**Report to Committee**

**To:** Planning Committee **Date:** April 28, 2011  
**From:** Brian J. Jackson, MCIP **File:** RZ 10-519918  
Director of Development  
**Re:** Application by Western St. Albans Venture Ltd. for Rezoning at 7500, 7520,  
7540 and 7560 St. Albans Road from Single Detached (RS1/E) to High Density  
Townhouse (RTH4)

**SITE SECTIONS**  
 SCALE 1/8" = 1'-0"

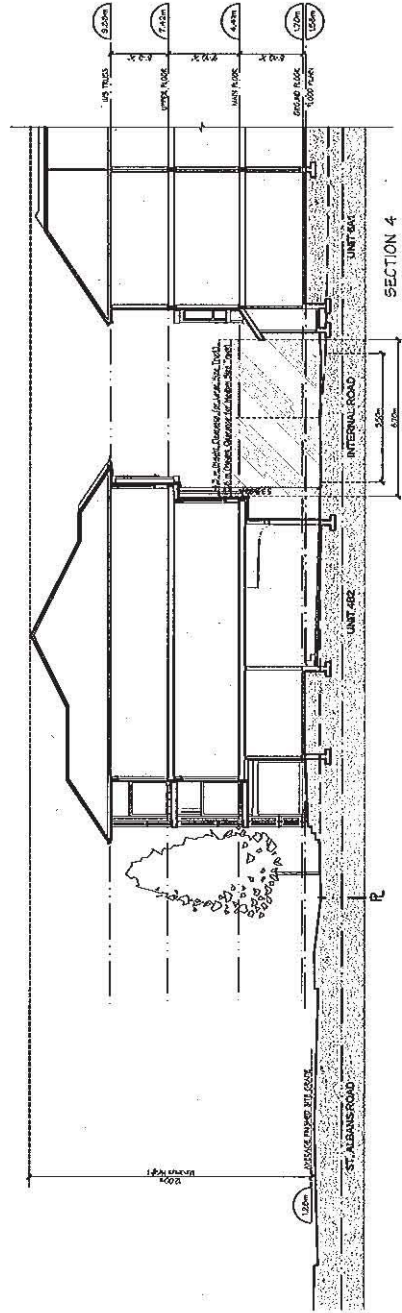
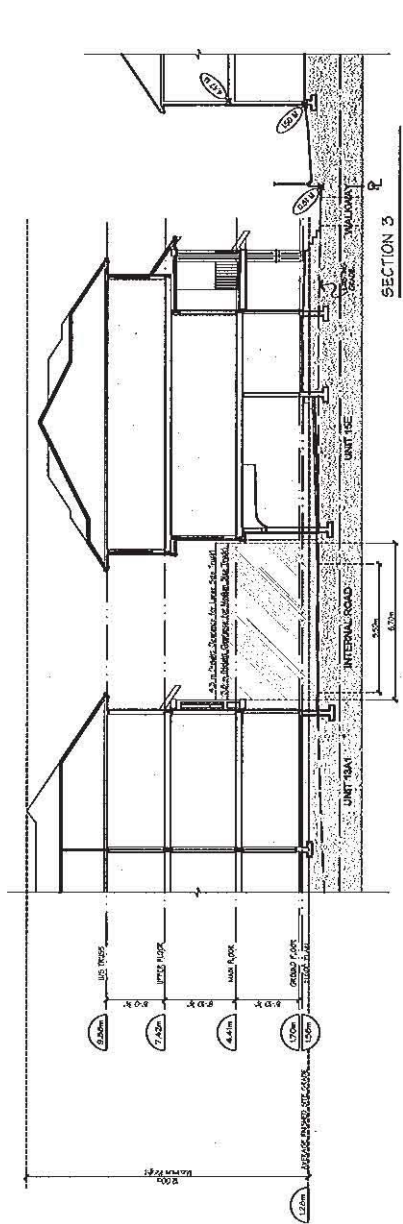
2. Concern that the proximity of the townhouses (and proposed balconies) to the east property line would reduce privacy and sunlight to the existing residential units in the adjacent apartment building to the east.

Looking at the Plans with the proximity of the townhouses and extending balconies to the property line, approximately 5', we are wondering if the balconies could be recessed to give us a little more space, more privacy, and more sunlight. In the surrounding buildings the depth to the lot boundary is much more significant than what is planned on this Site.

Also the ground level of the property, the way it currently sits, is about 3' below street level which, if built at that level, would reduce the height of the building quite substantially again providing more light and feeling of space as was done in the "Palms" at the corner of St. Albans and Granville.

*The developer has agreed to build the proposed townhouses along the east property on existing grade and has confirmed that the proposed balconies on the second floor are at a lower elevation than the neighbours' lowest decks.*

Drawing Title:  
 TREE RETENTION  
 PLAN

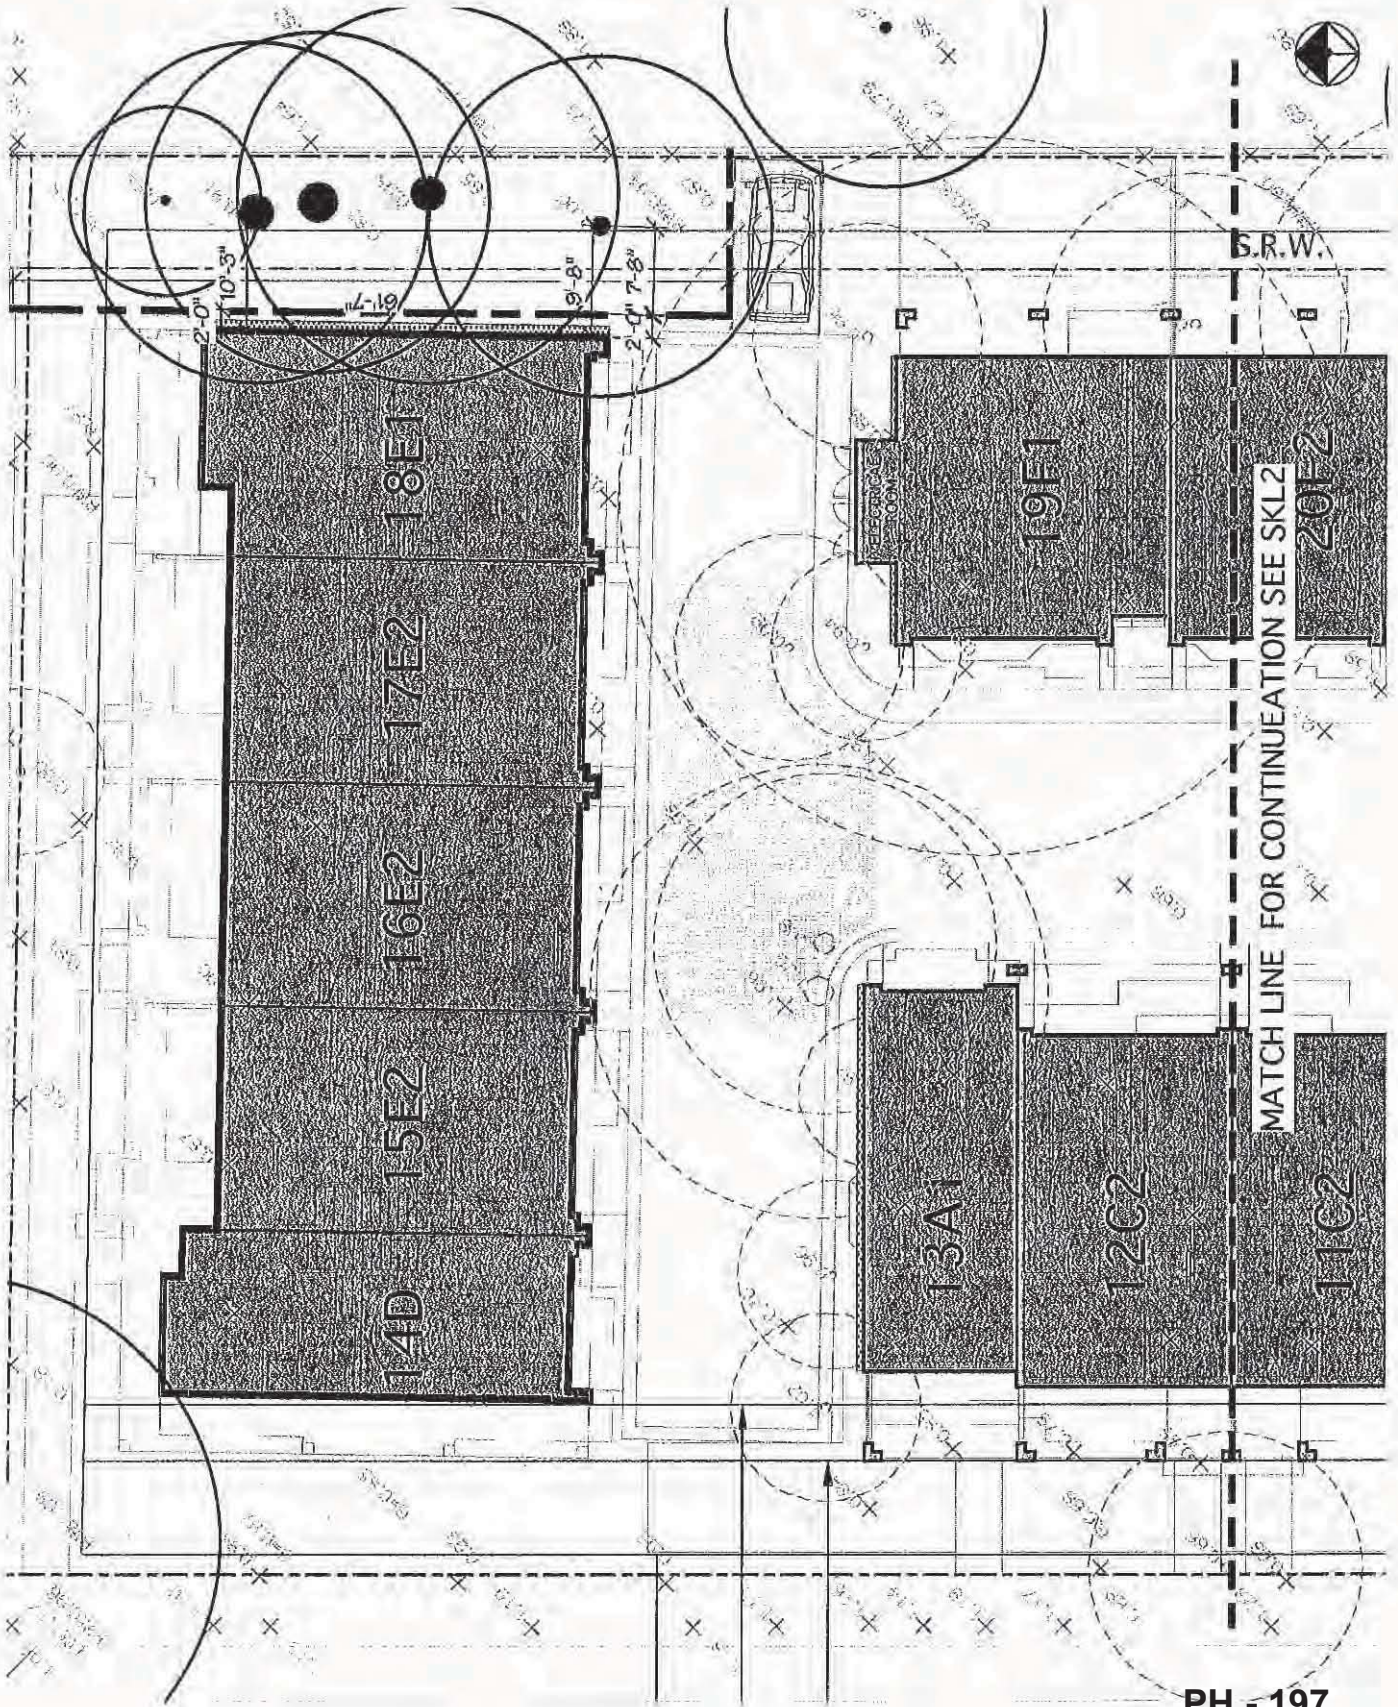
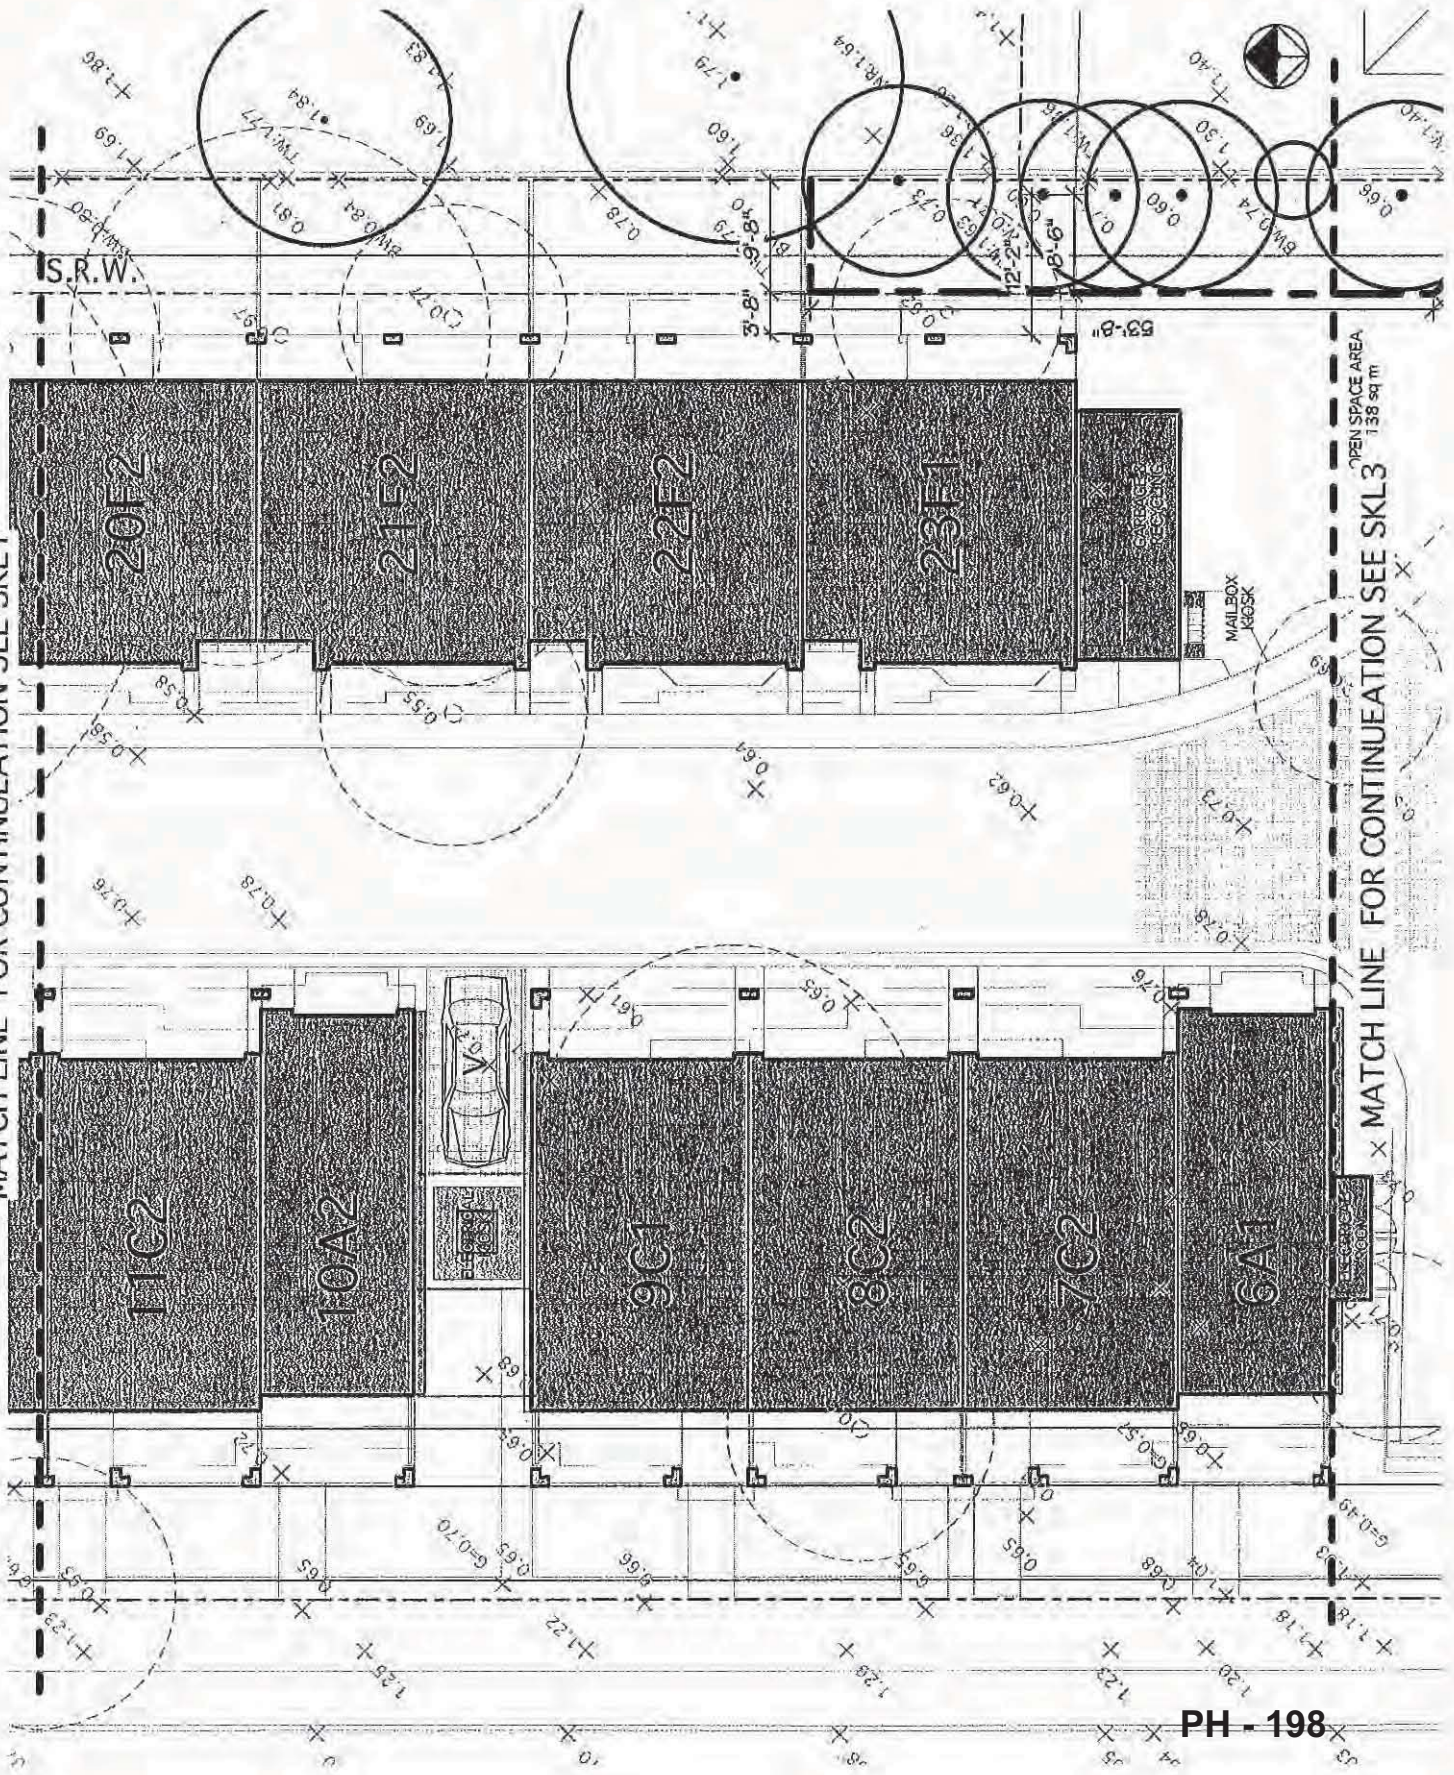
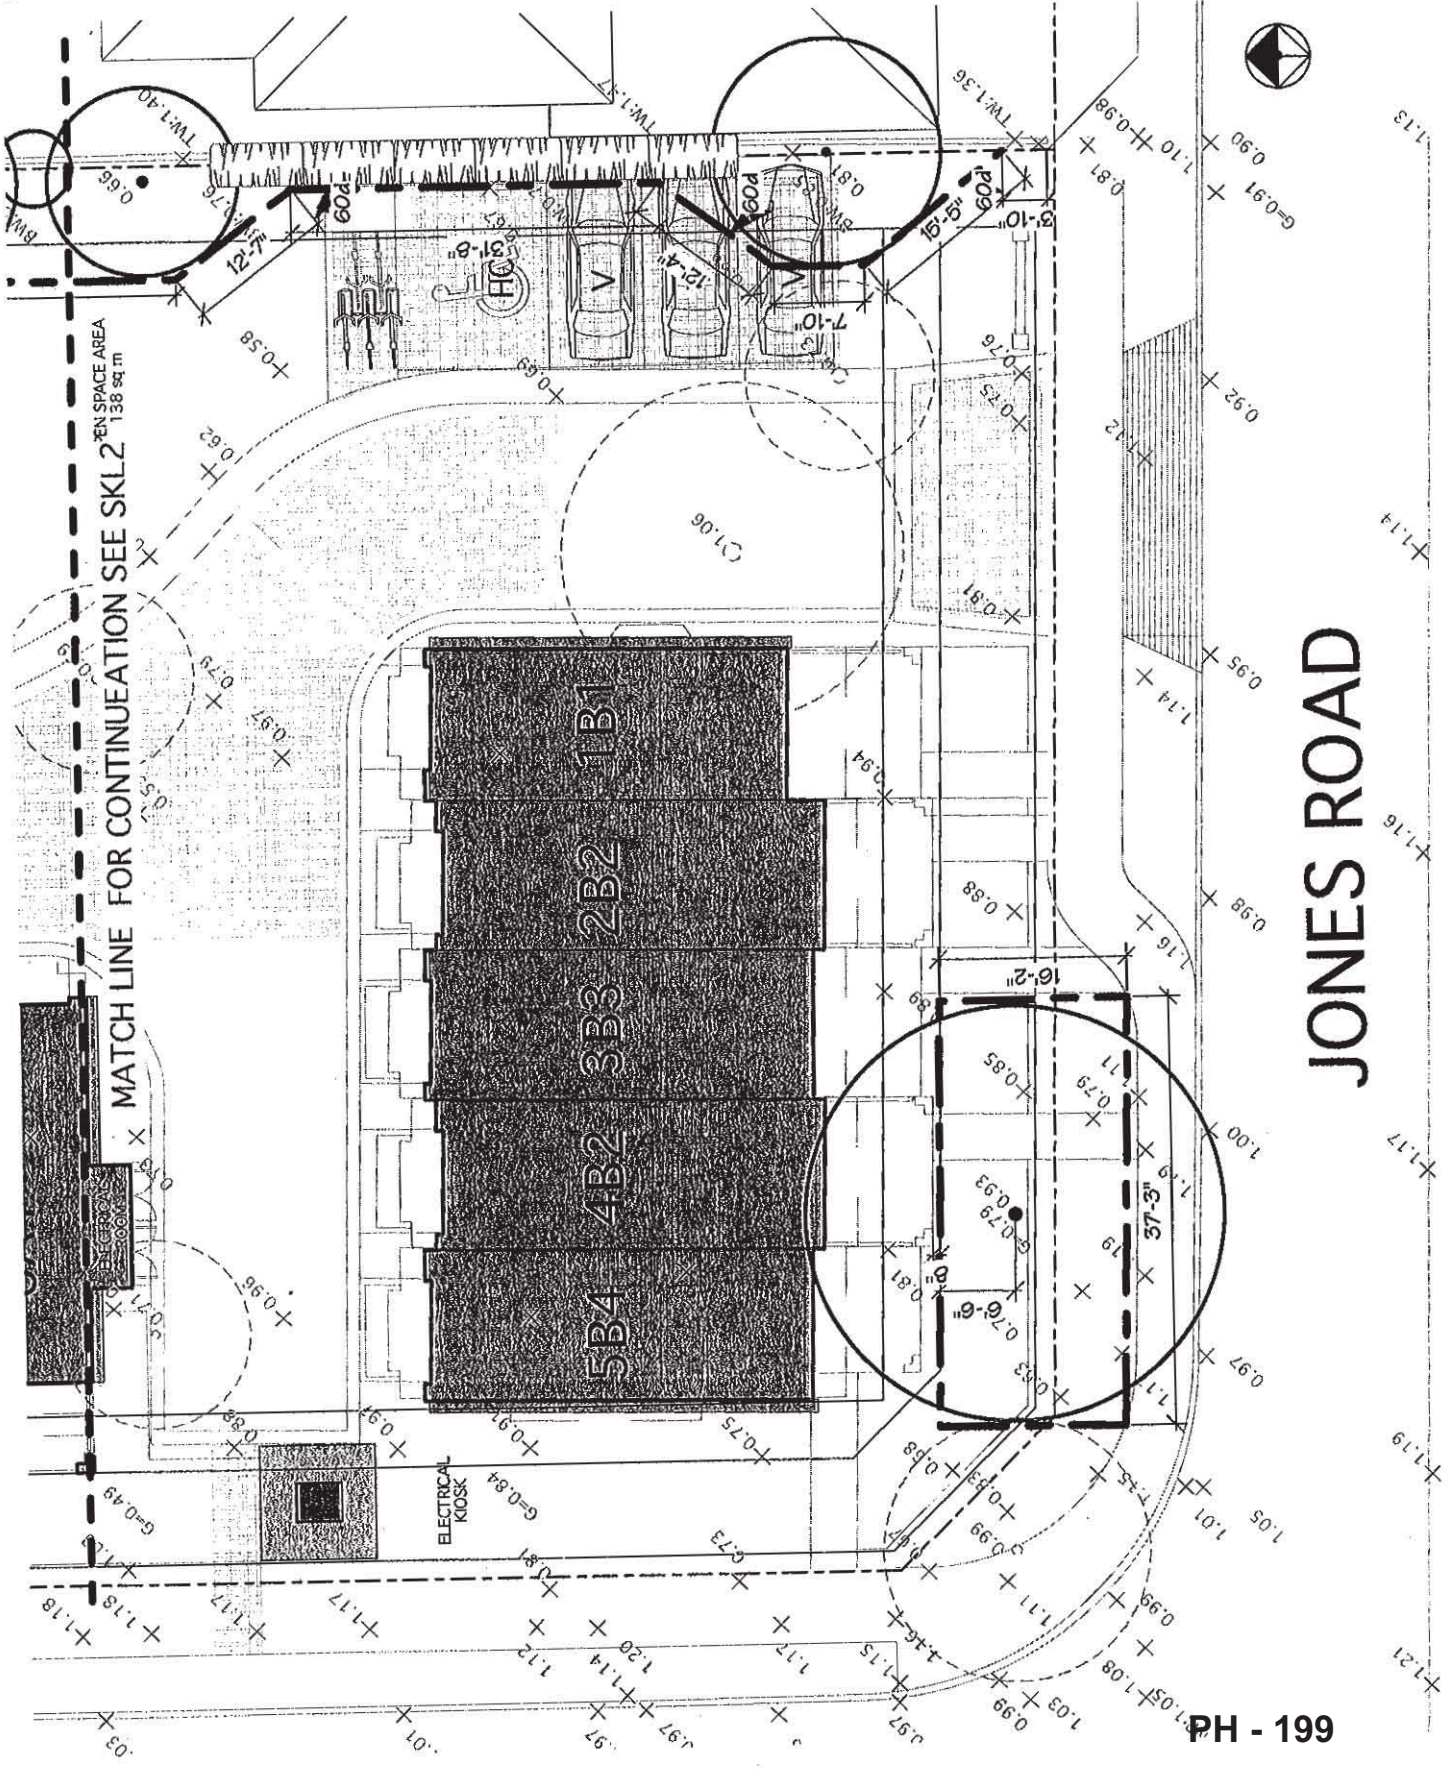
1. Concern that the coniferous trees which border the proposed development will be removed and the natural buffer between the apartment building and the development site will be lost.

We were advised by Mr. Lee that some of the trees, that we had been concerned about in an earlier letter to you, are now being kept and will not be destroyed as was indicated previously and we are grateful for that.

*The developer has agreed to preserve all of the trees along the east property line to maintain the natural buffer between the adjacent apartment building and the subject development.*

The applicant has committed to the retention of twelve (12) bylaw-sized trees on-site and all of the four (4) trees located on the adjacent properties to the north and east. All of the protected trees are along the east property line, except for a Beech tree located at the southwest corner of the site. The City's Tree Preservation Coordinator has recommended a 3.0 m building setback to the Beech tree. However, it is noted that the proposed setback from the covered porch on the ground floor and the decks on the second and third floor of the B-units fronting Jones Road to the Beech tree is only 2.0 m. In order to protect the Beech tree at the existing location, the project arborist recommended that the second floor deck be supported by small spread footings (and sono tube) off each corner of the deck. This will require only a very minor disturbance to the critical root zone. The project arborist has also recommended a custom designed support system that might involve a wood deck or a suspended slab for the ground level patio under the deck to ensure the site grades between the building and the tree be maintained at the existing elevation. The City's Tree Preservation Coordinator has reviewed and concurred with the project arborist's recommendations. Staff will work with the applicant on the building design to ensure tree protection at the Development Permit stage. A proof of contract with a Certified Arborist for supervision of on-site works conducted close to all protected trees and a tree survival security will be required at the Development Permit stage.
